10.4. NSW Government’s Crows Nest Transport Oriented Development rezoning proposal

The purpose of this report is to make a submission to the Department of Planning, Housing, and Infrastructure on the Crows Nest Transport Oriented Development (TOD) rezoning proposal that is being exhibited for public comment between 16 July – 30 August 2024.

Figure 6. Sun-eye diagram showing shadow impact of the Crows Nest TOD and Metro Site A at 4.10pm Spring equinox (21 September) (Source: NSC)

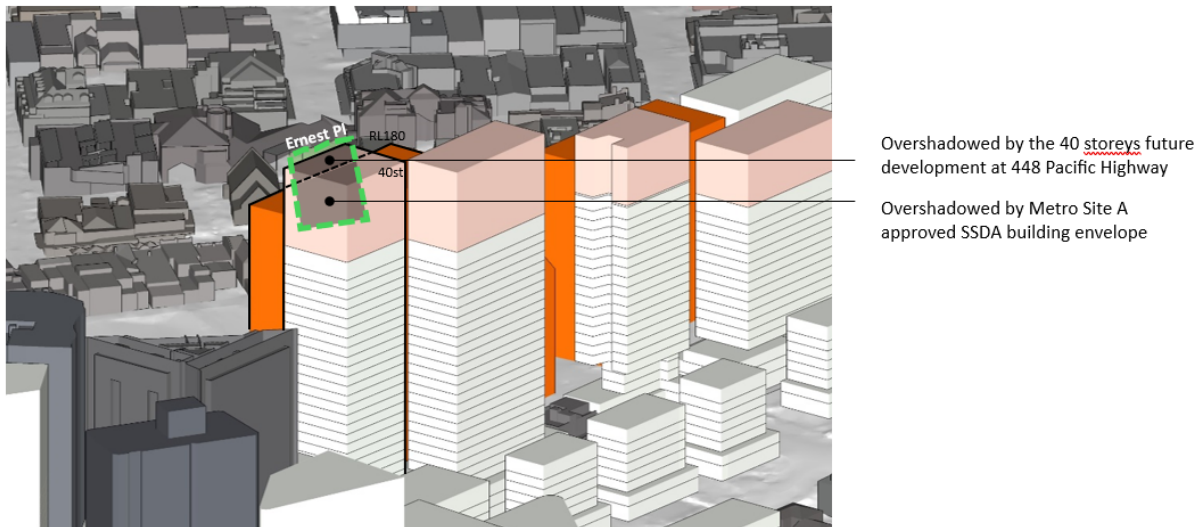
The affordable housing bonus provisions on the opposite side of the Metro (see Figure 6) will also now overshadow Hume Street Park, Willoughby Road, and Ernest Place later in the afternoon. It is recommended that the Department work with Council to identify ways to protect afternoon sunlight to these important and well used community spaces.

Figure B2.1: Building heights comparison between 2036 Plan and Crows Nest TOD at Block 3 (Source: Urban Design Report marked up by NSC)

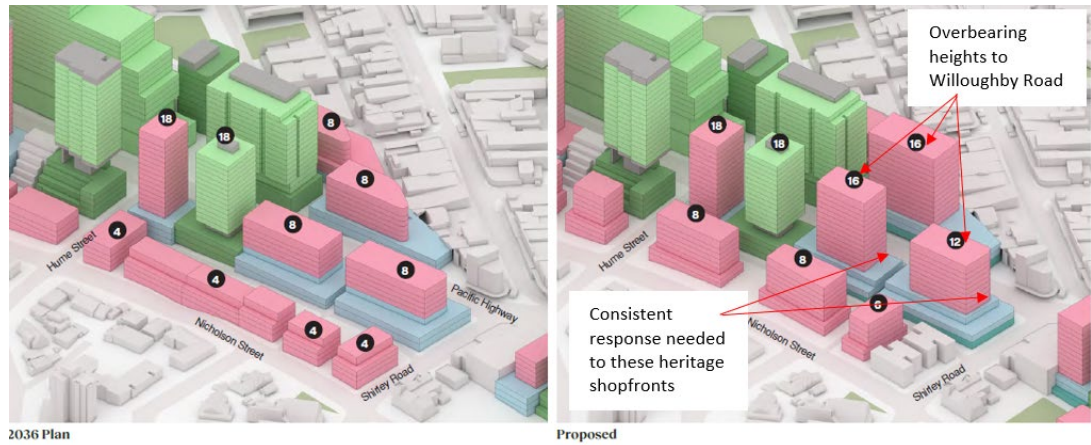
Building 1, which is located adjacent to properties fronting Willoughby Road is proposed to have its building height increased from 8 storeys (as per the 2036 Plan) to 16 storeys (refer to Figure B2.1 and B2.2).

Buildings 2 and 3, located on the south-western side of Pacific Highway, are proposed to increase in height from 8 storeys (as per the 2036 Plan) to 16 and 12 storeys (refer to Figures B2.1 and B2.2).

Figure B2.2: Building heights recommendation at Block 3

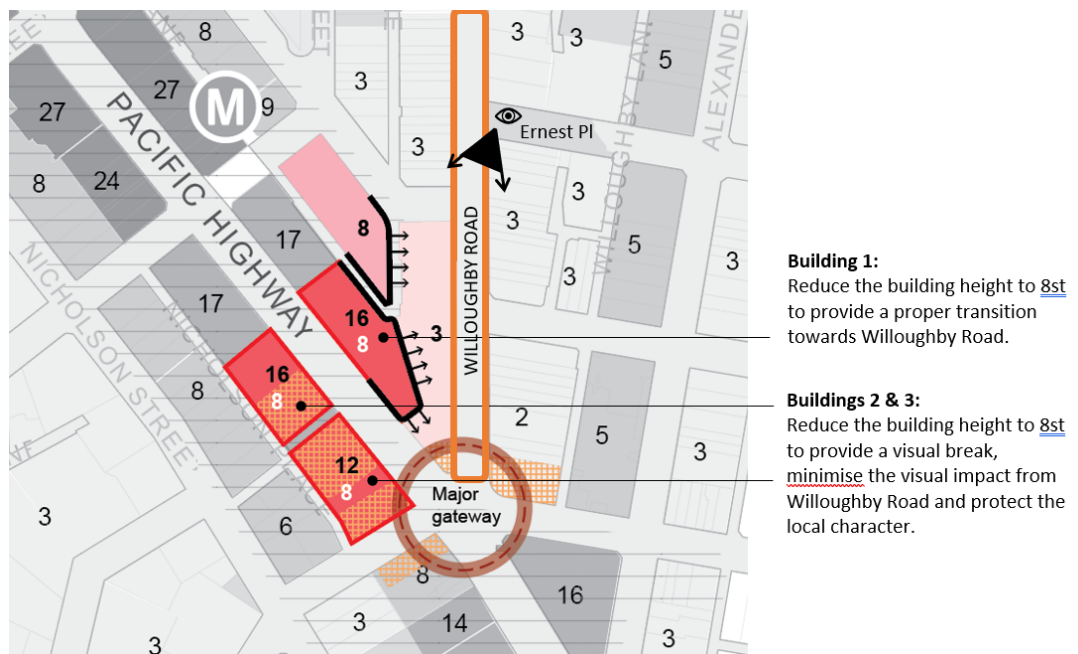
To protect this local character and provide appropriate scaled development over this group of heritage façades, it is recommended to retain the consistent 8-storey building height from the 2036 Plan, with a 4m setback above the podium, as advised in the Crows Nest TOD Urban Design Report. This approach would largely conceal the buildings behind the development on the north-eastern side of Pacific Highway, create a visual break, respond to the heritage façades, and preserve the fine-grain local character (refer to Figure B2.3).

- Building 1:**
Reduce the building height to 8st to provide a proper transition towards Willoughby Road.
- Buildings 2 & 3:**
Reduce the building height to 8st to provide a visual break, minimise the visual impact from Willoughby Road and protect the local character.

Figure B3.3 – Proposed building heights diagram (height in storeys) Figure B2.4 – Proposed LEP HOB map (height in metres)

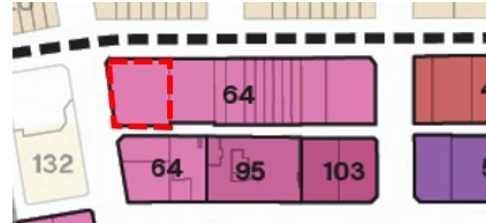
Other sites that are envisaged to accommodate 12 storeys have been afforded a maximum height of 43m. Accordingly, a maximum 43m height limit should be applied to this site.

Furthermore, increasing the height limit to that proposed on this site would have detrimental impacts on solar access to Christie Street Reserve, which is inconsistent with the desired solar access outcomes of the EIE Package.

Figure B7.1 – Propose setback controls map – misalignments and unsupported changes

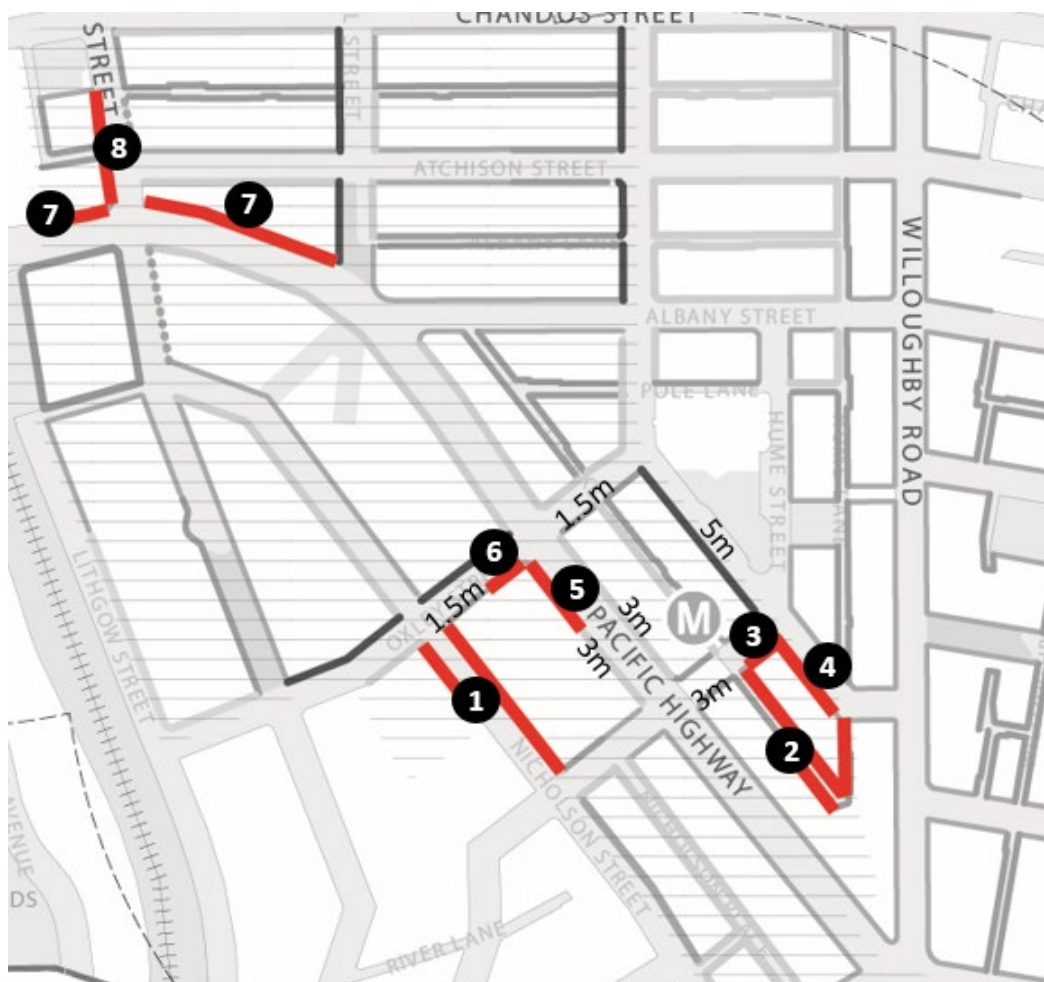
Additionally, the proposed setback controls seek to introduce several modifications in comparison to the 2036 Plan and North Sydney Development Control Plan (NSDCP 2013). Upon review, it is evident that some of the proposed setbacks are not supported as they undermine the desired character of the area and negatively impact on local amenity.

Further details on these issues are provided in the accompanying list and diagram (see Figure B7.1).

Figure B8.1 – Proposed street wall heights map – misalignments and unsupported changes

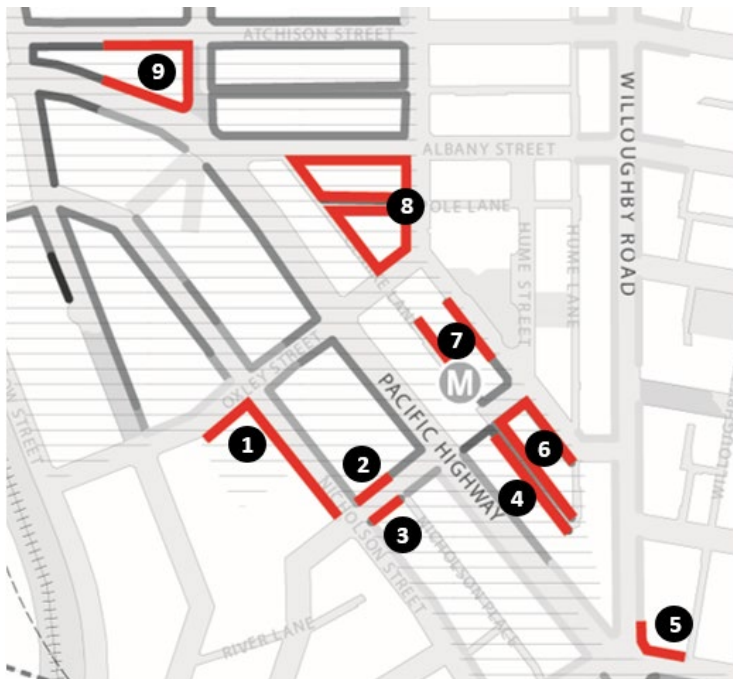
Several discrepancies are noted between the proposed podium height controls in the 3D views, sections, and control map. It is crucial that the Design Guide accurately reflects these controls.

Additionally, some proposed podium heights differ from those under the 2036 Plan and the NSDCP 2013, and are not supported. Details are provided in the accompanying list and diagram (see Figure B8.1) below.

Figure B10.1 – Hume Street Park

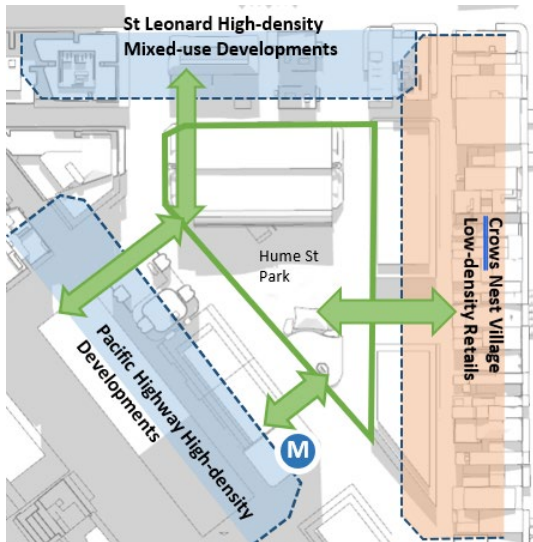
It is evident that the proposed uplift to the Lot 4B development site in the Willoughby LGA, will have a significant impact on Wadangari Park, located on the southern side of Pacific Highway atop the railway line. The resulting increase in density on this site will cause additional shadowing, especially between 2pm and 3pm in mid-winter (see Figure B10.2), resulting in this Park only achieving 50% solar access between 12pm and 1pm. Before 11am and after 2.30pm, the park will be fully shaded.

This situation reinforces the need to deliver a high-quality, recreational space with high levels of solar access. Hume Street Park is well located within the heart of Crows Nest to serve both the local community and visitors. It is also capable of receiving high levels of solar access, due to the need to protect the low-rise character of Willoughby Road to the east. Accordingly, public domain opportunities and related funding mechanisms for upgrade, expansion and embellishment of Hume Street Park need to be considered and included in the Design Guide.

Figure B22.1 - Land use map from Design Guide

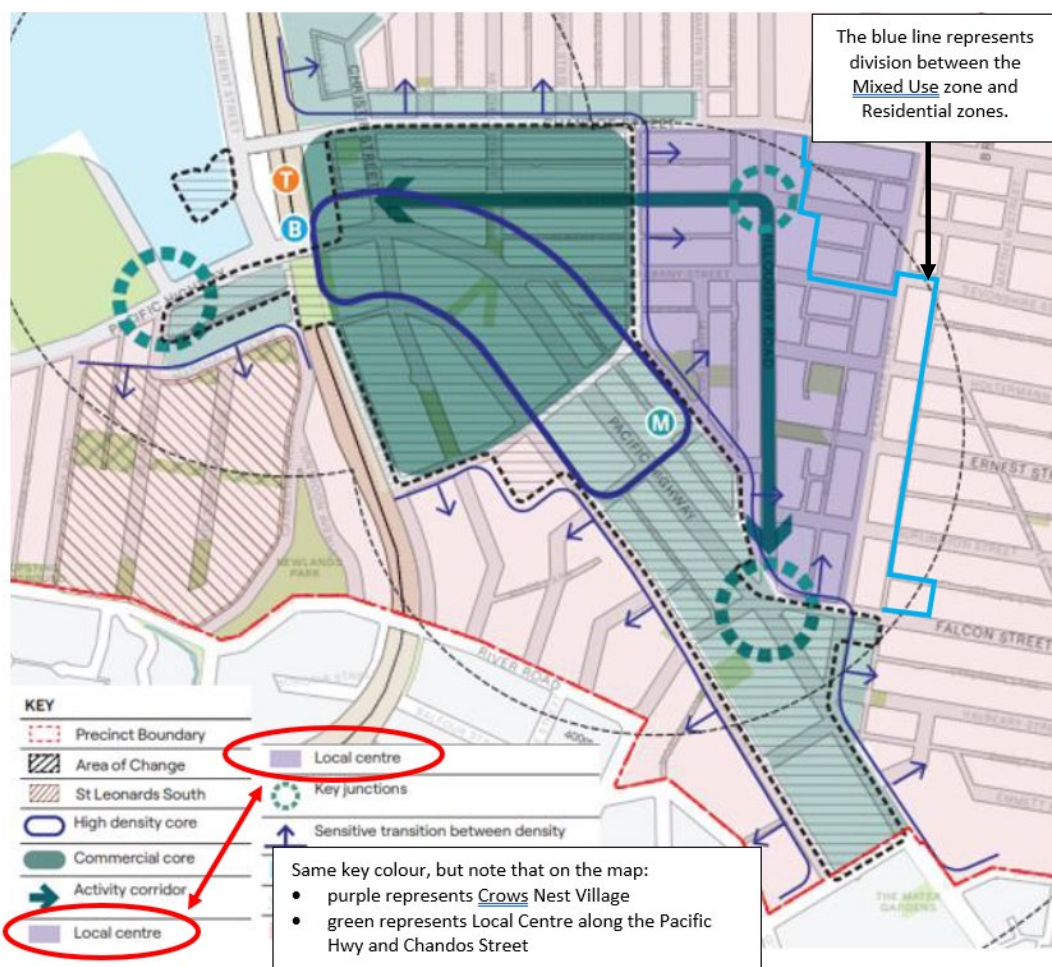
The land use map contains a number of errors in relation to the extent of the Crow Nest Village (local centre) and the key.

The Map incorrectly labels the mixed-use zones along the east side of Alexander Street between Falcon Street and Devonshire Street as residential areas. In addition, a residential area generally located between zigzag Lane, Chandos Street, Aleander Street and Albany Street is shown as part of the local centre (refer to Figure B22.1)

This error needs to be corrected to accurately reflect the intended land use.

Figure B24.1 – Built form design recommendations – Urban Design Report

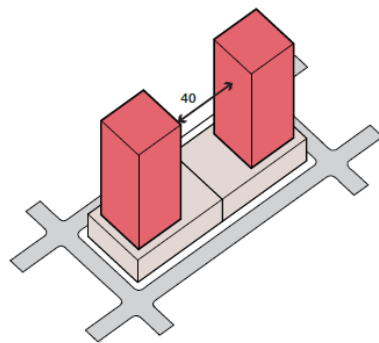
The Urban Design Report suggests a 40m separation between towers along Pacific Highway (see Figure B24.1) to enhance sensitivity to the local character and context.

To preserve amenity for Wollstonecraft residents and pedestrians, it is recommended that a new provision be provided within the Design Guide requiring:

Figure B28.1: Extract of Figure 8 to the Design Guide and extent of missing public open spaces where solar access is to be protected.

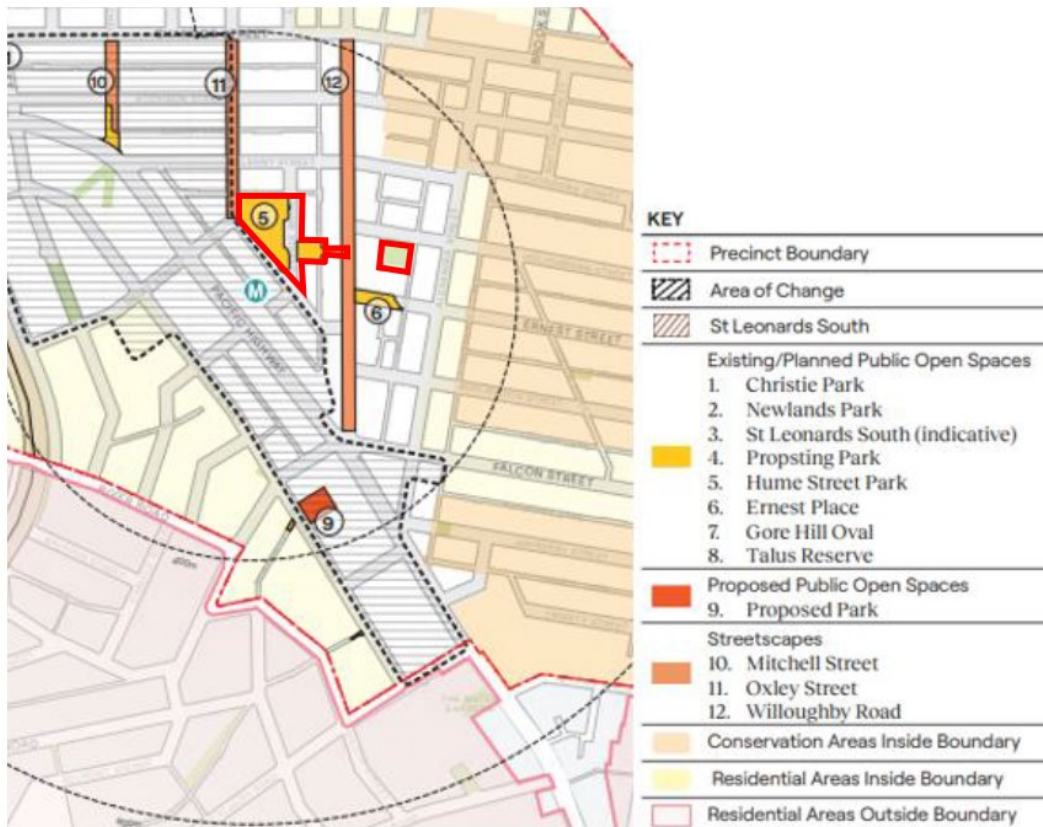
The proposed solar access map fails to correctly identify the full extent of Hume Street Park, which includes the road reserve of Hume Street. This road reserve is zoned as RE1 in the North Sydney Local Environmental Plan (NSLEP2013) and is expected to be transformed into part of Hume Street Park in the long term. The solar access map should be updated to reflect this consolidated space accurately.

Additionally, no solar access protection is being proposed for any future Holterman Street Park, as identified in the 2036 Plan. The NSDCP2013 includes a solar access protection control for this future open space. It is recommended to add Holterman Street Park to the solar access protection areas.

Figure B32.1 – Block 4 section – Urban Design Report

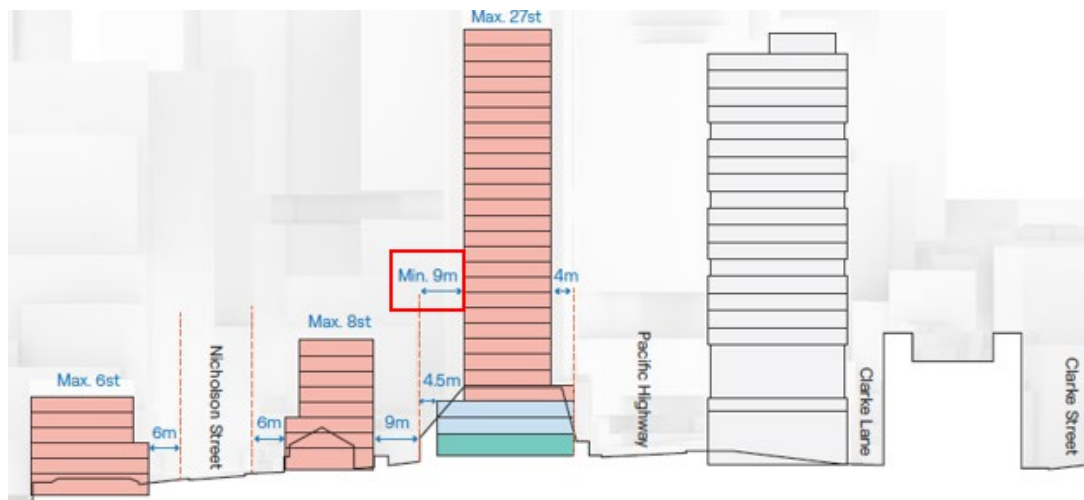
The cross sections from the Urban Design Report for opportunity blocks detail minimum tower setbacks along Nicholson Street and Sinclair Street (see Figure B32.1), which are reflected in the 3D models and align with the proposed FSR. However, these setback controls are not reflected in the Design Guide. To ensure the intended design outcomes are met, it is essential to include these minimum tower setback controls within the Design Guide.

Figure C5.3: Sun eye diagram at 4.10pm on 21 Sep - Ernest Place

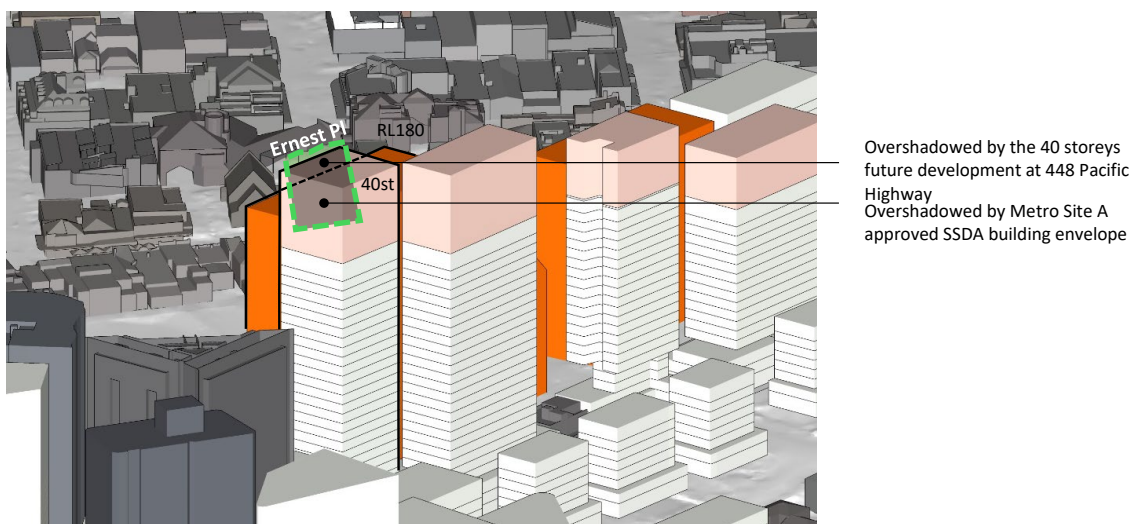
If the affordable housing incentives are taken up at 448 Pacific Highway, it will create additional overshadowing impact to Ernest Place and Willoughby Road, beyond the anticipated impacts of the envelope to Site A of the Crows Nest Metro OSD (refer to Figure C5.3). This additional overshadowing impact is unacceptable as the approved Crows Nest Metro OSD building envelope already creates significant shadow impacts and visual impacts to Ernest Place and Willoughby Road within the Crows Nest village.

It is recommended that the State Government collaborate with Council to refine the planning controls for 448 Pacific Highway and Site A to the Crows Nest Metro OSD to reduce the overshadowing impacts to Ernest Place and Willoughby Road.

- Recommendations:**
- Defer any amendments to 448 Pacific Hwy and engage in collaboration with the Council to ensure alignment with the long-term vision for the Precinct.

Figure D2.1 – LEP non-residential FSR map – reduction in non-residential FSR

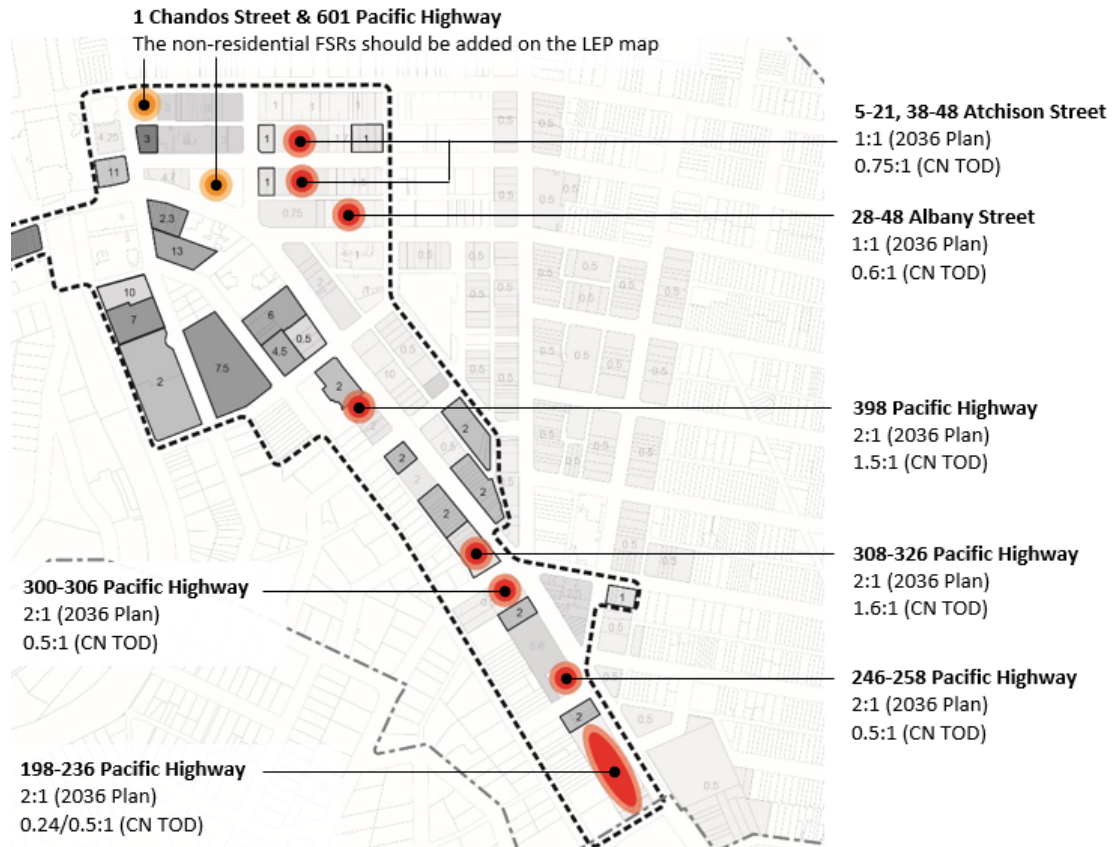
Under the review process, it has been observed that the non-residential FSR for some sites has been reduced compared to the 2036 Plan (see Figure D2.1). While increasing housing supply is a priority for NSW and the proposed uplift aims to address this objective, it should not come at the expense of the non-residential FSR crucial to the Precinct’s commercial vitality. Increased density is anticipated to drive additional demand for retail and commercial services. Therefore, to uphold the Precinct’s designated commercial role, it is essential to retain the non-residential FSR as specified in the 2036 Plan. Council opposes any reduction in non-residential capacity for St Leonards and Crows Nest.

Therefore, it is essential to include the minimum non-residential FSR controls on the map to ensure the preservation and promotion of non-residential uses within this key commercial core area.

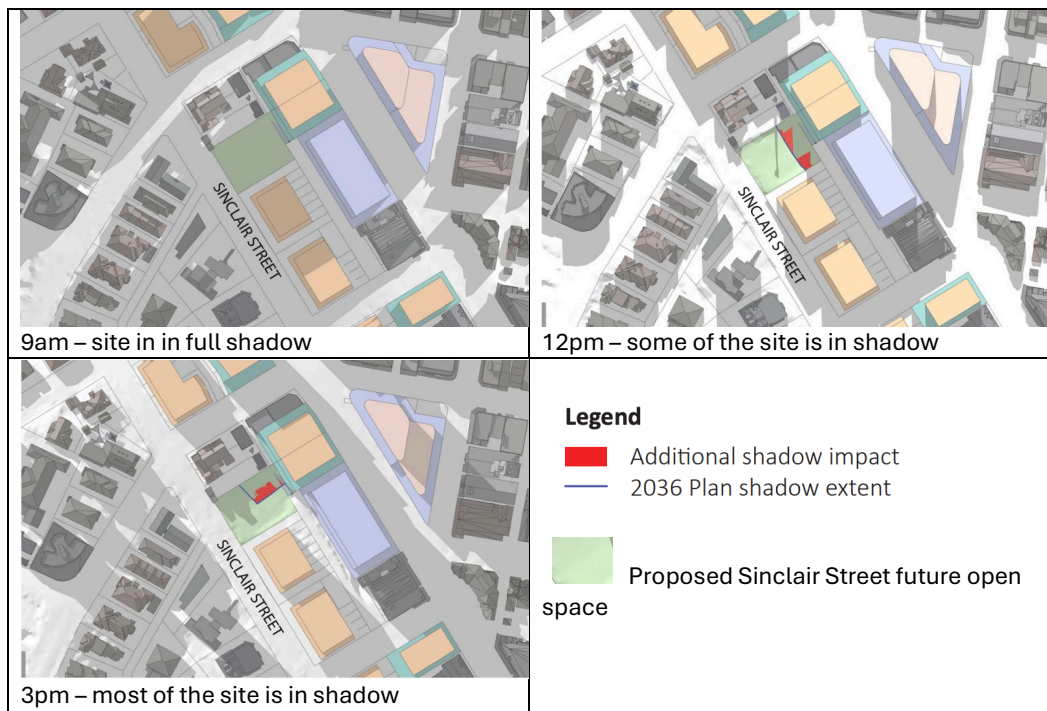
Figure I1.2. shows the impact of over-shadowing on the proposed open space in Sinclair Street (on 21 June 2024).
